## **Staff Report for Heritage Richmond Hill Meeting**

**Report Number:** SRPI.21.093

**Subject:** SRPI.21.093 Heritage Permit Application for  
10155-10157 Yonge Street; Hewison-Skeelee  
House and Shop – File D12-07458

**Figure 1:** Front elevation showing proposed changes to building.

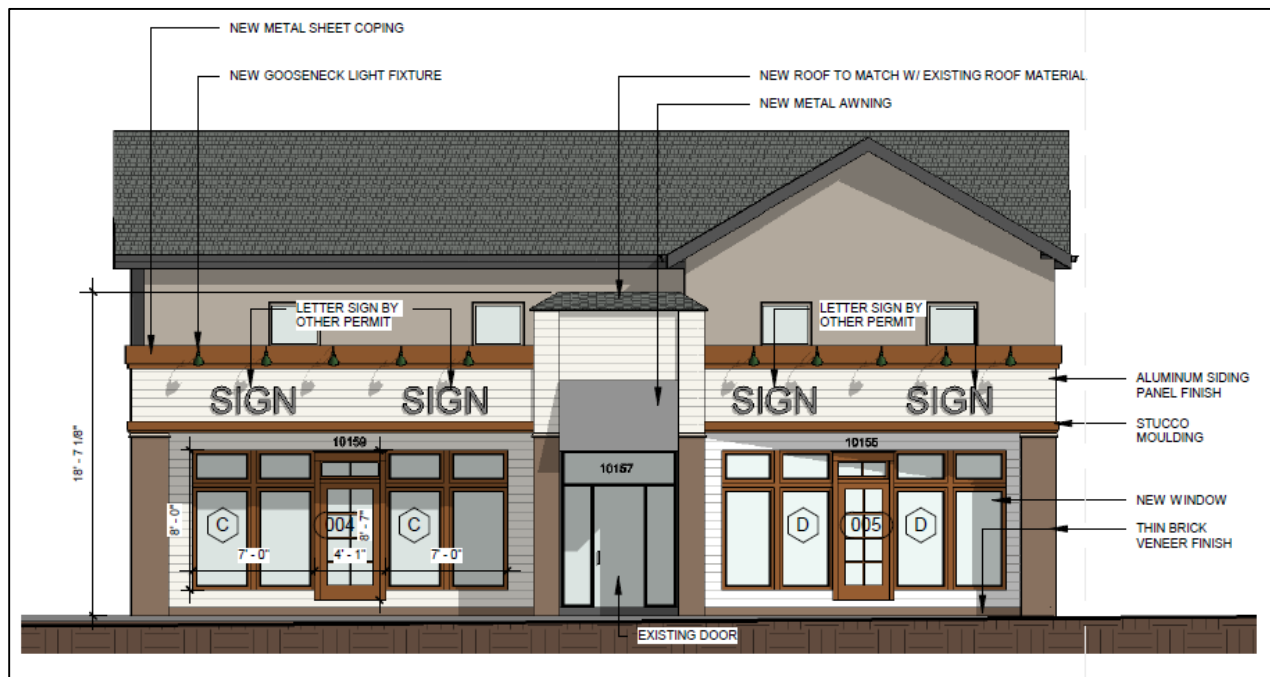
The work proposed in the Heritage Permit application focuses solely on the front façade of the Hewison-Skeele House and Shop. While the changes will have a visual impact on the entire front façade, the physical changes are limited to the 1948 storefront addition.

Currently, the building is clad in stucco. The project proposes to add a brick veneer finish to the narrow walls that protrude from either side of the two storefronts, and clad the rest of the first storey façade in aluminum siding.

The entrances to the two storefronts will be modified to have identical central doors, double paired windows on either side of the doors, and a row of transom windows above the doors and windows.

The centrally located entrance will remain unchanged except for the overhang above the entrance, which will be extended upwards and clad in aluminum siding. Metal awning will also be installed.

The signage area above the two storefronts will be extended upwards and clad in aluminum siding, with stucco moulding along the lower edge, new metal sheet coping along the upper edge, and gooseneck lighting. Specific details on the signage that will be installed in the future will be done through a separate sign permit, and will have to abide by the City's signage by-law.

The storefront elevation of the Hewison-Skeele House and Shop was altered in 1948 with the addition of a one-storey addition that juts out towards the street from the original building. The storefront has undergone modifications since then that detract from the building's original historical architecture. The changes to the storefront of the front façade reflect traditional 19<sup>th</sup> and early 20<sup>th</sup> century storefront design, and complement the property's history. Using historical elements such as gooseneck lighting, and recreating porch column elements through the use of a brick veneer complement the building's historic architecture. These changes will also create a more harmonious front façade.

Staff recommends that the Heritage Permit application be approved.
